# 1988 - 1989 Corvette: Recall Notice: Rear Wheel Tie Rod

**Bulletin No:** 89C17

Subject: PRODUCT SAFETY CAMPAIGN 89C17  
REAR WHEEL TIE ROD

Model and Year: 1988-89 CHEVROLET CORVETTE

**FIGURE 1**

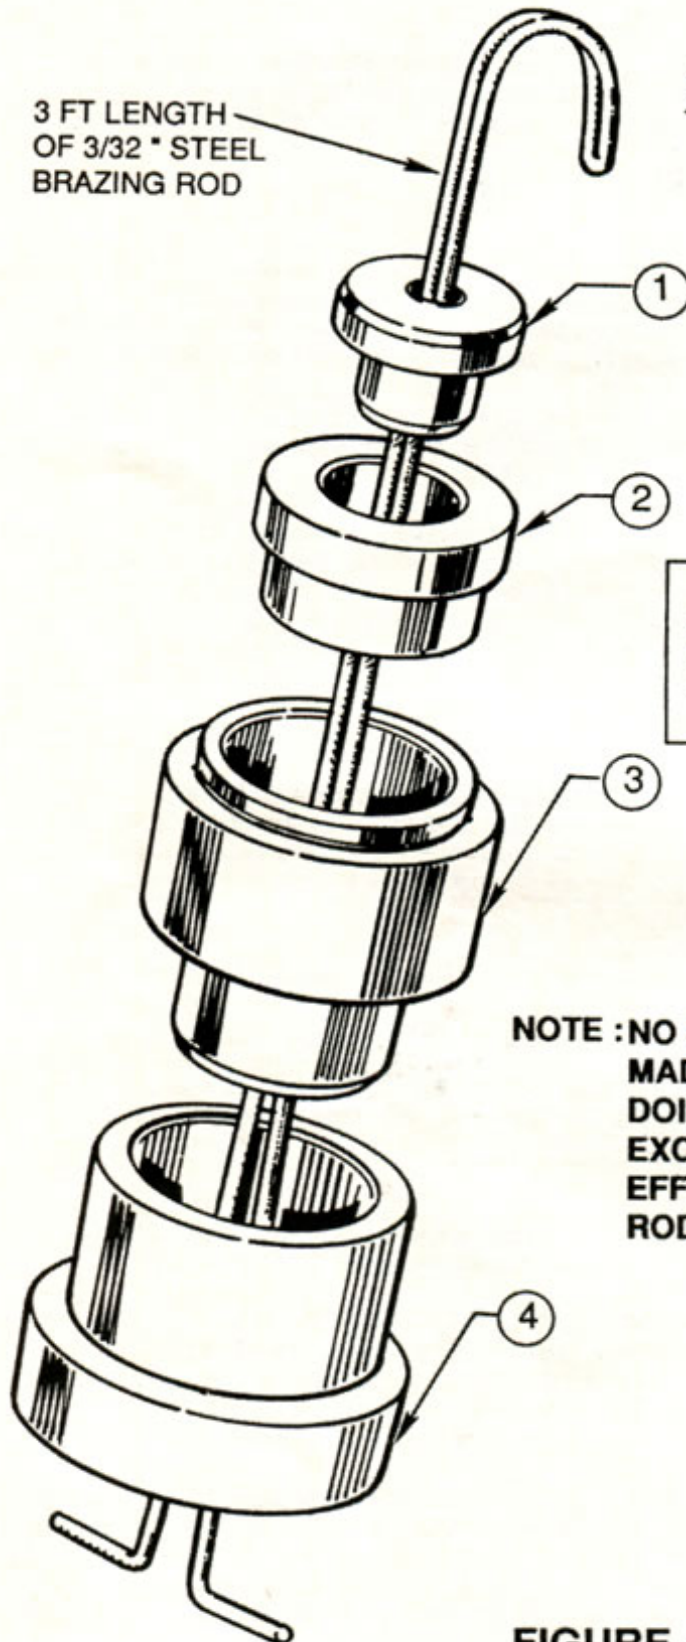
1. Fabricate/Assemble weight from materials indicated and as illustrated in Figure 1.
2. Raise Vehicle.
3. Remove cotter pins, nuts and washers from both outer rear tie rod ends and disconnect from knuckle assemblies utilizing tool J-24319-01.

**NOTE : NO SUBSTITUTIONS SHOULD BE  
MADE FOR THE TOOLS INDICATED.  
DOING SO, MAY RESULT IN AN  
EXCESSIVE WEIGHT WHICH COULD  
EFFECT THE ACCURACY OF TIE  
ROD INSPECTION.**

FIGURE 2

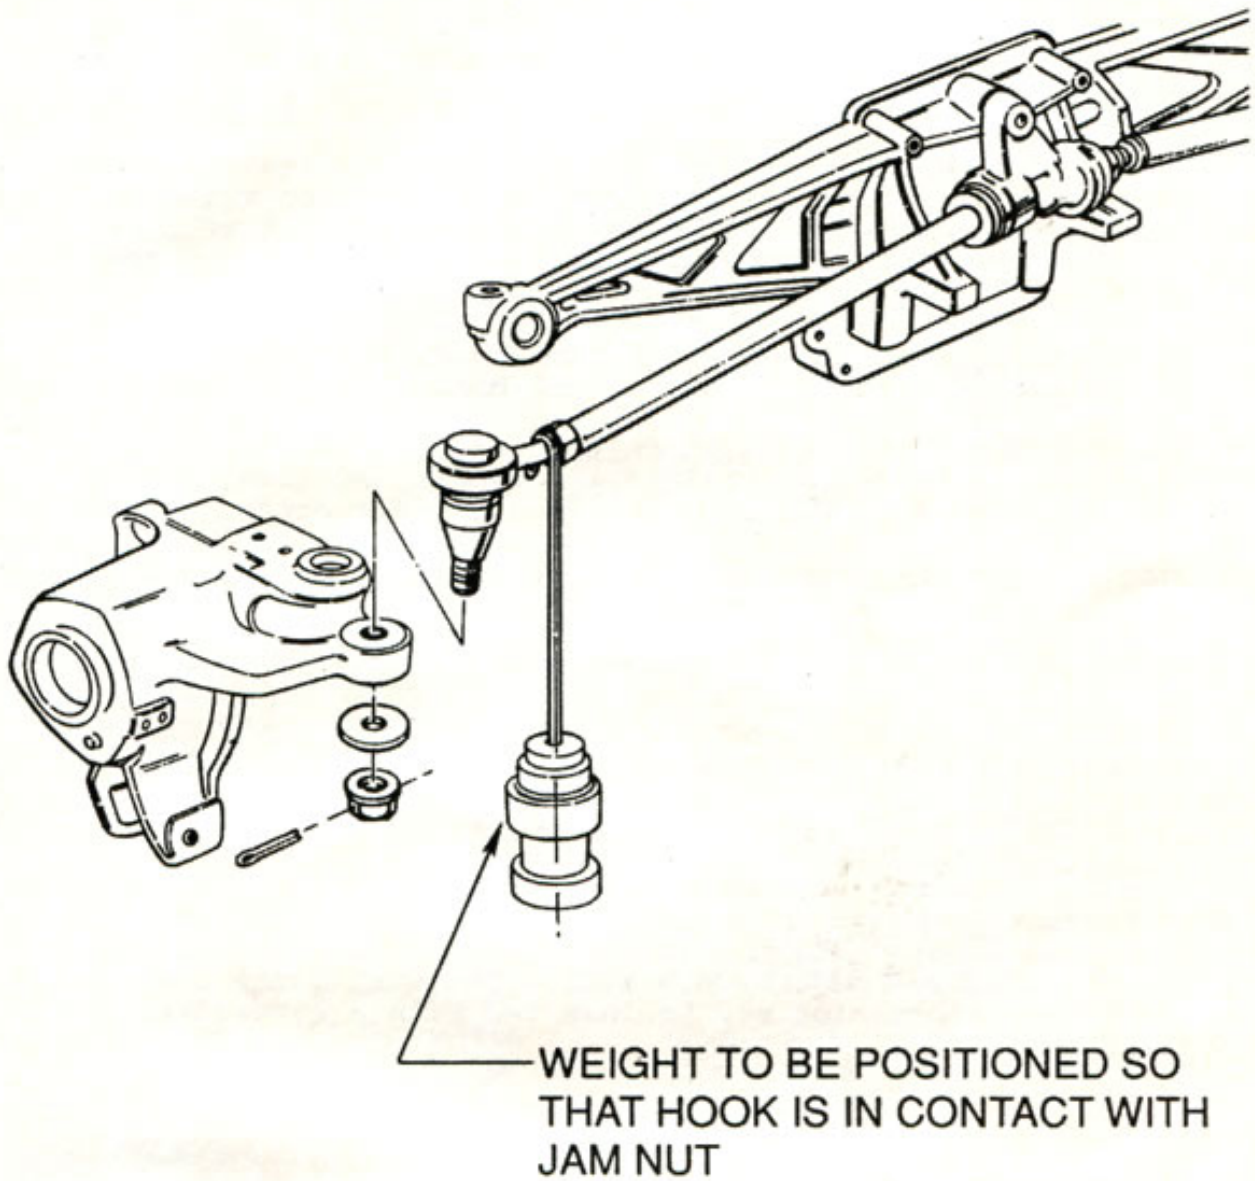
4. Raise and hold outer end of left hand tie rod linkage in its upper most position, insuring rod is not rotated while being raised. Attach weight as shown in Figure 2, release linkage and note results. Repeat procedure on right hand tie rod linkage.
5. Based on observations noted in performing step 4, select appropriate action from those noted below:
  - A. Linkage moves downward on both sides - Reconnect tie rod sockets to knuckles, install washers and nuts, torque nuts to 45 Nm (33 lbs. ft.) and install cotter pins.
  - B. Linkage on either or both sides doesn't move downward - Replace tie rod assembly, transferring existing tie rod ends to new assembly and following Section 3D in the Chevrolet Corvette Service Manual of the appropriate year.
6. Install Campaign Identification Label.

To prevent this condition from occurring, involved vehicles will be inspected to determine the amount of rocking torque on each tie rod. Tie rod assemblies above 12Nm rocking torque on either side will be replaced.
